# UNITED STATES PATENT AND TRADEMARK OFFICE

10/620,154

<b>Office Action Summary</b>	Application No. 10/620,154	Applicant(s) TALABER ET AL.	
	Examiner Anu Ramana	Art Unit 3733

### **DETAILED ACTION**

FIG. 6

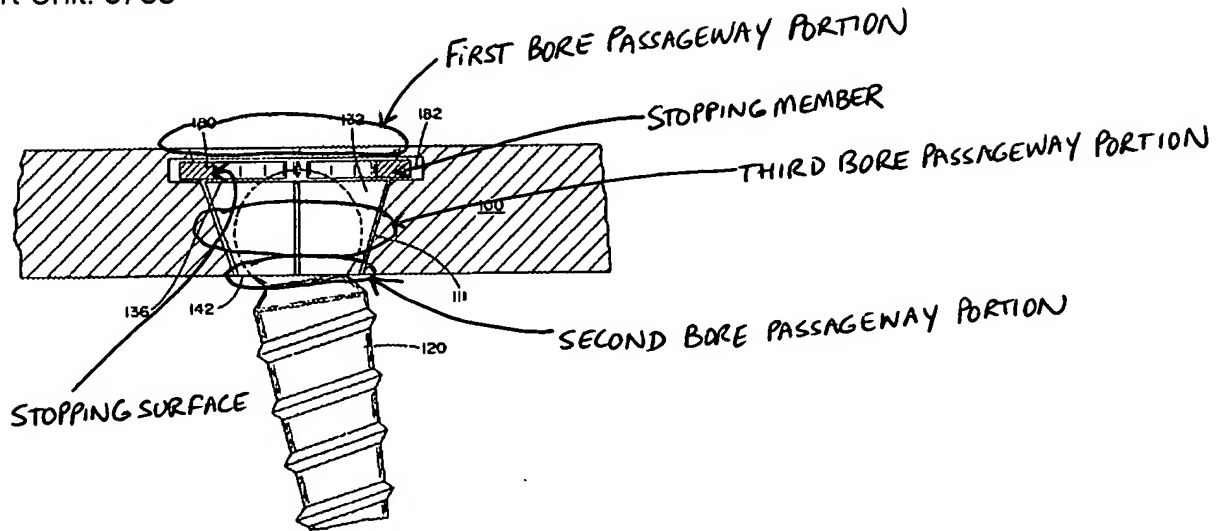
Errico et al. disclose an attachment component or stabilizing element 100 including: a bore 111 having a first bore passageway portion and a second bore passageway portion with at least one smaller transverse dimension than the first bore passageway portion; a stopping member 180 having a biased stopping surface; and a third bore passageway portion between the biased stopping surface and the second bore passageway portion having a surface configured to conform to the enlarged portion or head of the securing component (Fig. 6, col. 5, lines 41-67 and col. 6, lines 1-55). See marked up Figure 6 from Errico et al. below.

Regarding claim 45, a fixation element such as a plate conforms to the surface of the underlying bone and thus could have a curved surface.

Regarding claims 94 and 95, it is noted that resilient stopping member 180 deflects radially as well as longitudinally due to its resilient nature.
